# BMW Motorrad USA

## Service Information Bulletin

### **\*\*Recall 08V-342\*\***

**Subject:** Replacing steering damper

Fig 2: Example, K 1200 R (K43)  
View from top right

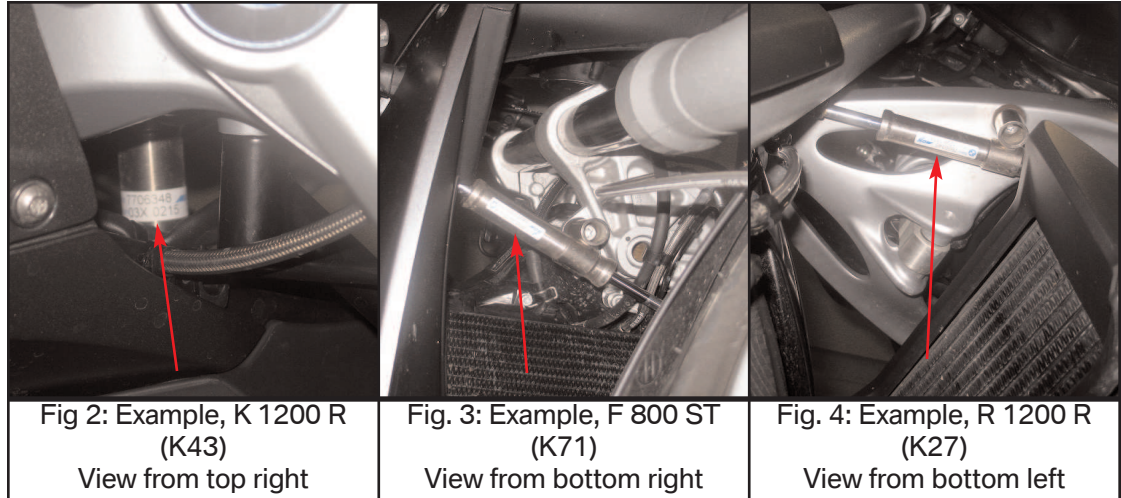
In the case of most of the motorcycles potentially affected by this problem, the position of the label is such that it will not be necessary to remove components in order to read the information on the label. The label on the steering damper of the K4x models can be viewed from above (right side) (see Fig. 2, pg. 2). On all the other models the label is easily read from below the motorcycle (see Figs. 3 and 4, pg. 2).

The steering damper must be replaced if the information shows that it is in the range of production numbers affected by this problem, but please note that it is also necessary to replace the damper if the information is illegible or if the label is no longer affixed to the damper.
